# INDIANA DEPARTMENT OF ENVIRONMENTAL MANAGEMENT

June 28, 2024

Re: Confined Feeding Operation  
Approval Renewal  
**Reauthorization of Construction**  
Approval Facility Change  
Top Grade Production LLC  
Howard County  
Farm ID #3713  
Animal Waste Number AW-6822

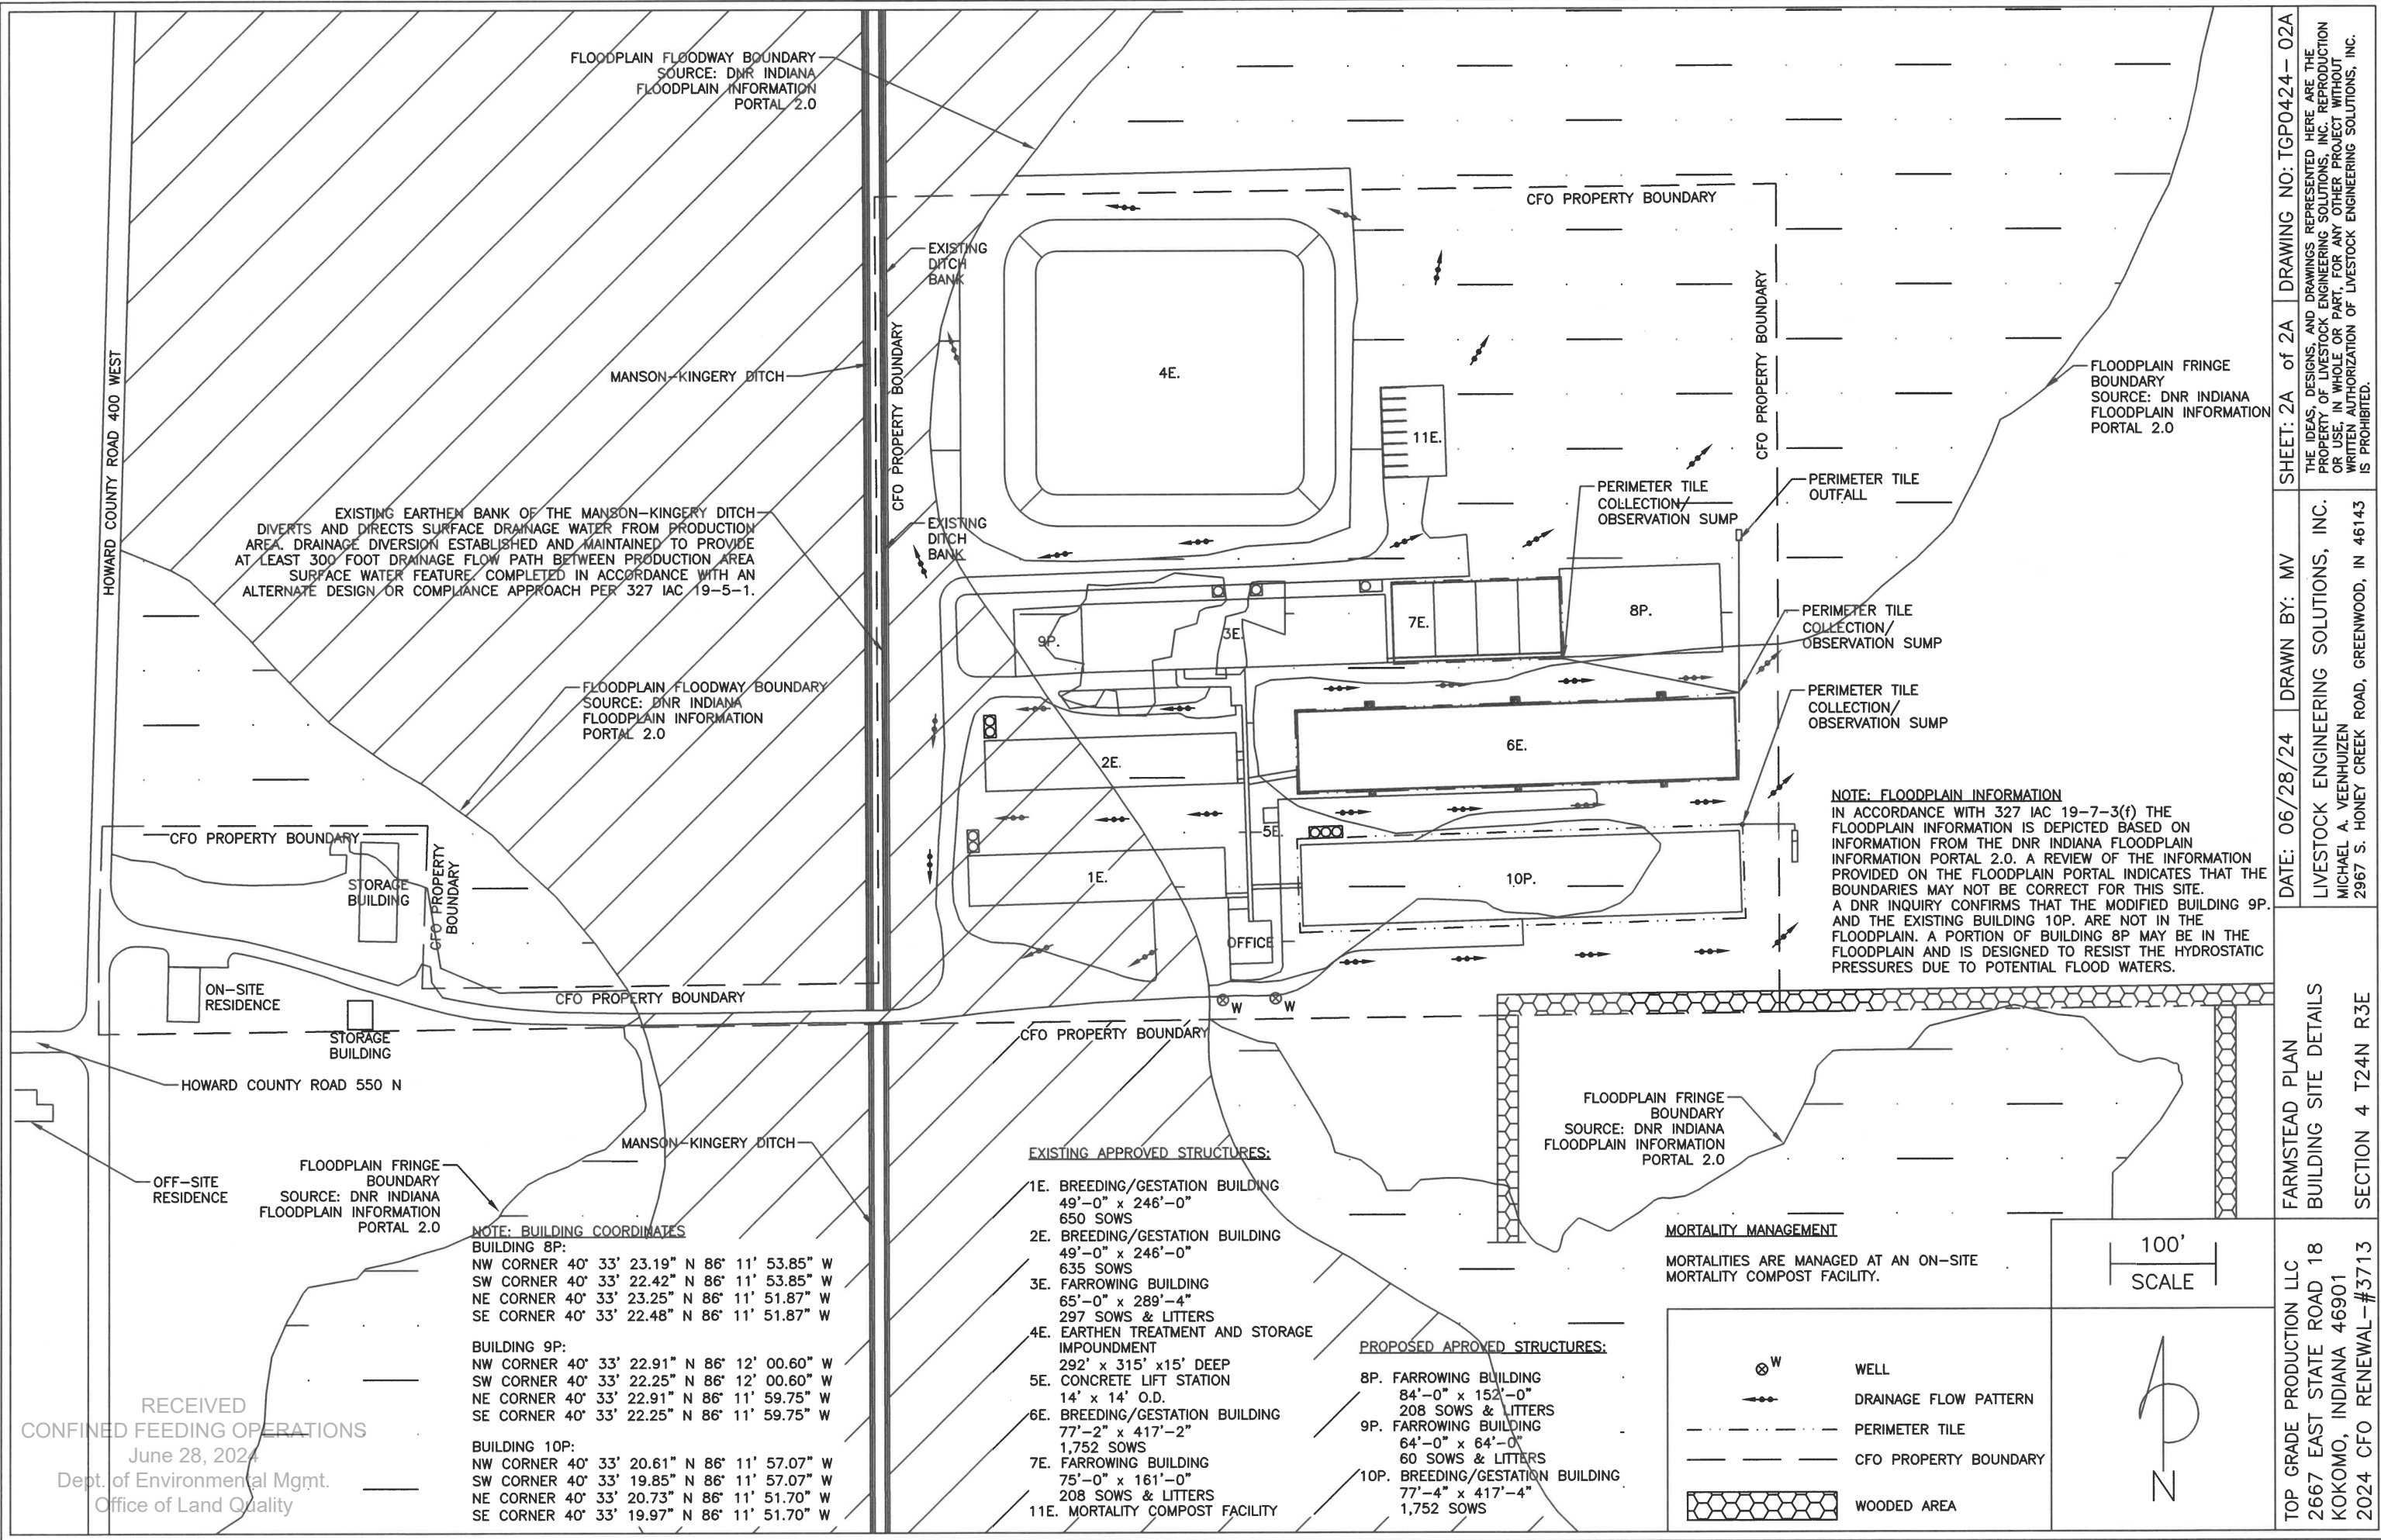
- The designs of swine confinement structures 8P and 9P have been modified to accommodate the floodway and floodplain fringe that have been mapped on the site after the structures were originally approved.

- Updated Farmstead Plan Sheet 2A to include floodplain and updated building dimensions and operating capacity. A copy of the DNR Indiana Floodplain Information Portal 2.0 map for the confined feeding site is added to show the current floodplain floodway and fringe boundaries depicted on Farmstead Plan Sheet 2A. (plan sheet 2A and floodplain map)

The coordinates have been updated on plan sheets 2A and 2C. Updated copies are included. Please replace the previously submitted plan sheets to update the application packet.

FARROWING BUILDING  
FOUNDATION PLAN  
BUILDING 8P

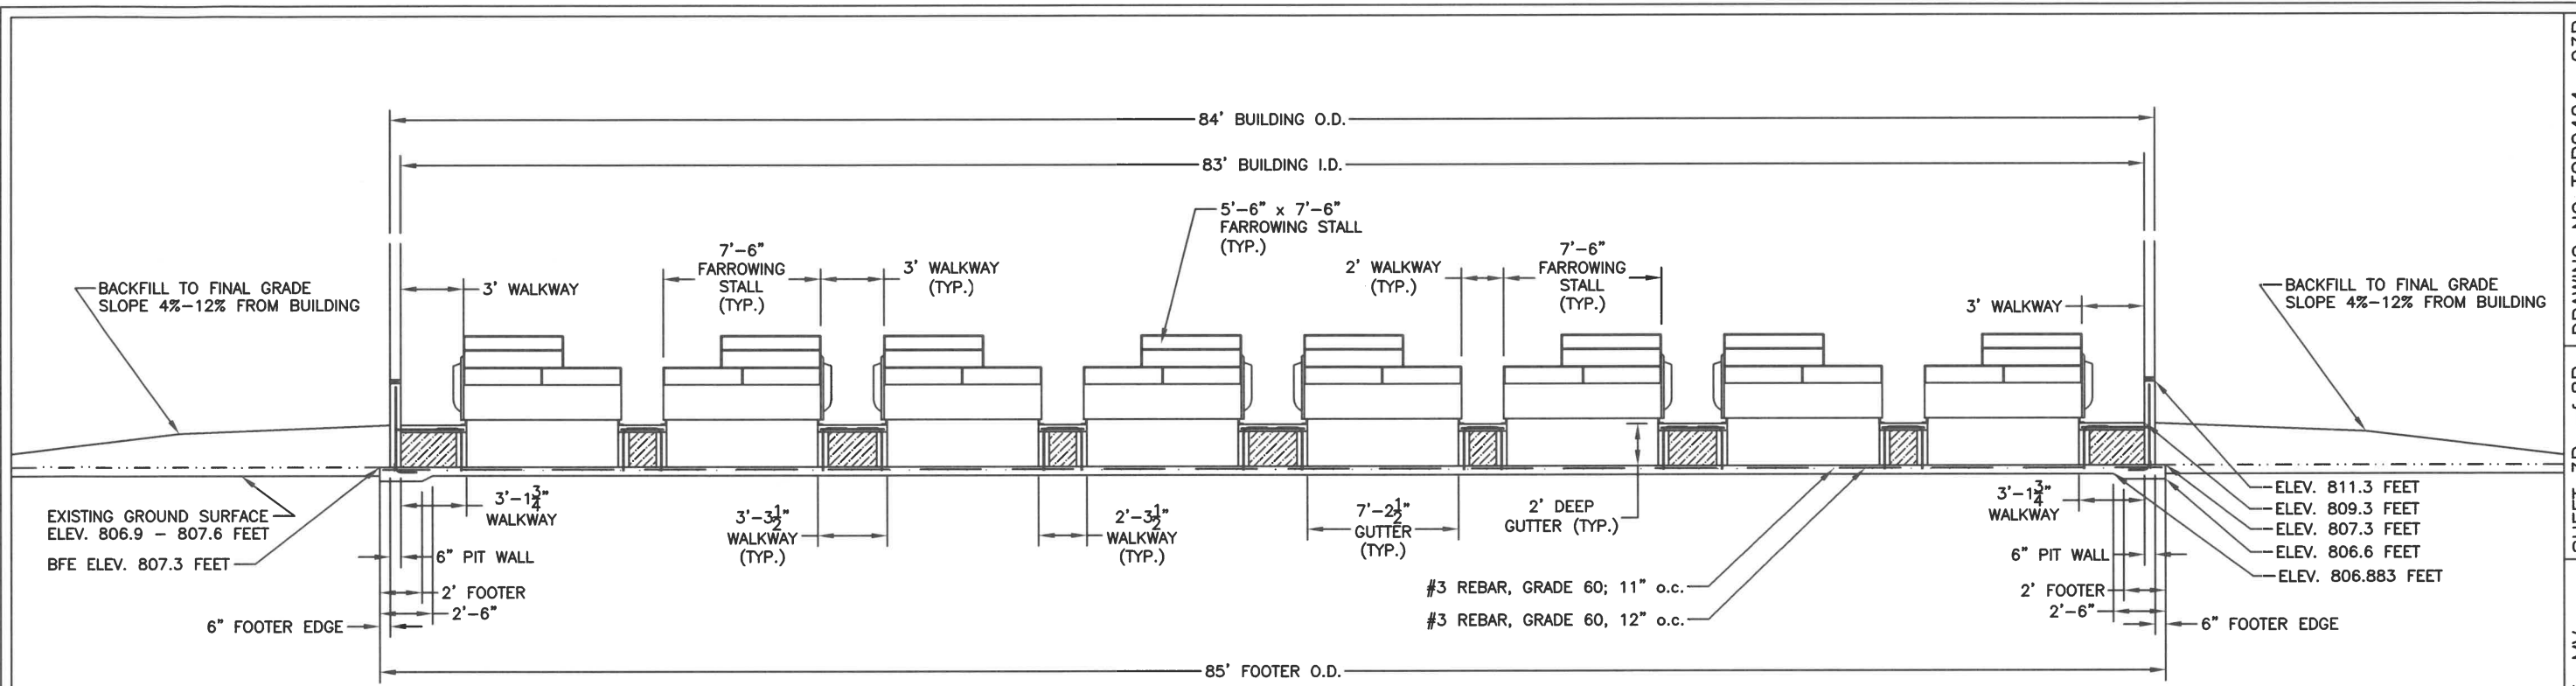
3. Plan Sheet 2B of 8B: Thank you for the opportunity to review the details shown on the plan sheets. A review of plan sheet 2B confirms that Detail B-3B faces west and Detail B-3B on plan sheet 3B is correct. It is noted that there are two clean-outs planned on the 8" diameter PVC gravity drain line. The clean-out on the north side of the building was not labeled. A label has been added to plan sheet 2B to identify the clean-out on the north side of the building. Referring to Detail B-3B on plan sheet 3B the cleanout located on the north side of the building is visible and is correctly shown on the right side of the page. The clean-out on the south side of the building is east of the Detail B-3B section line on plan sheet 2B and is not visible on plan sheet 3B when facing west.

Plan sheet updates: Plan sheets 2B and 3B have been updated to include the beginning and ending elevations of the 8" diameter PVC drain pipe. Updated plan sheets 2B and 3B are included.

TOP GRADE PRODUCTION LLC 2667 E STATE ROAD 18 KOKOMO, INDIANA 46901 2024 CFO RENEWAL - #3713	FARROWING BUILDING FOUNDATION PLAN BUILDING 9P	DATE: 06/28/24 DRAWN BY: MV	SHEET: 2C of 8C	DRAWING NO: TGP0524-02C
---	--	--------------------------------	-----------------	-------------------------

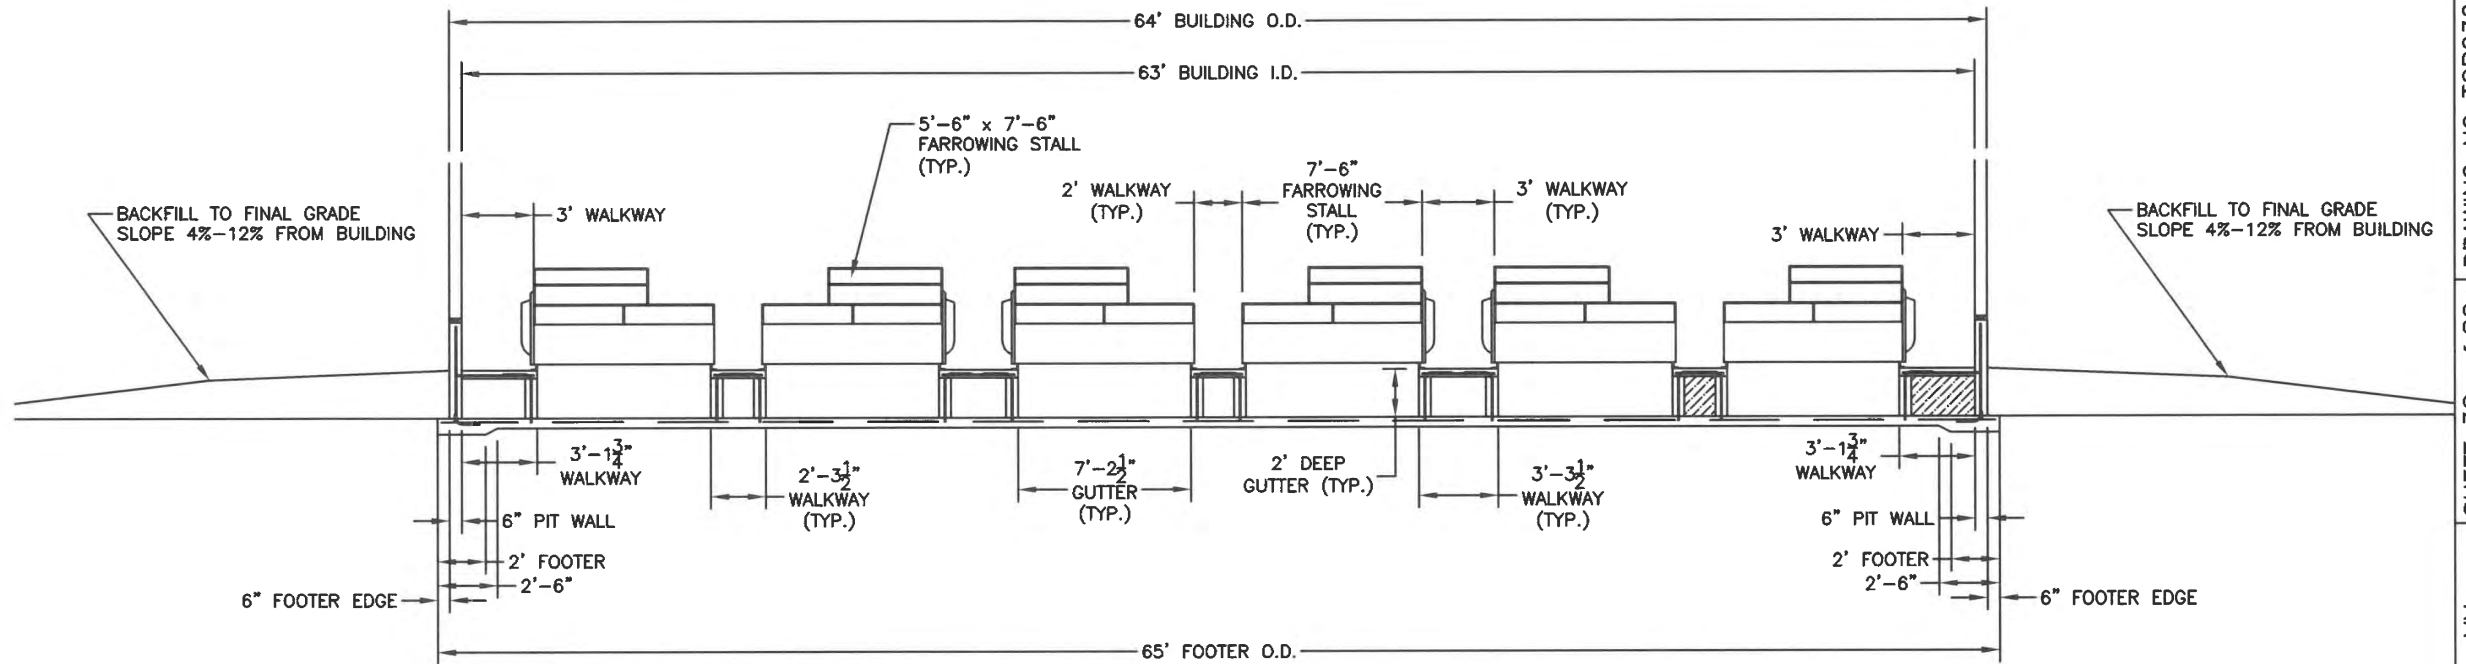
A review of plan sheet 2C confirms that Detail B-3C faces west and Detail B-3C on plan sheet 3C needs to be updated. There are two clean-outs planned on the 8" diameter PVC gravity drain line. The clean-out on the north side of the building was not labeled. A label has been added to plan sheet 3C to identify the clean-out on the north side of the building. Both clean-outs are visible when Detail B-3C section line is facing west. Plan sheet 3C has been updated to identify both of the planned clean-outs in Detail B-3C.
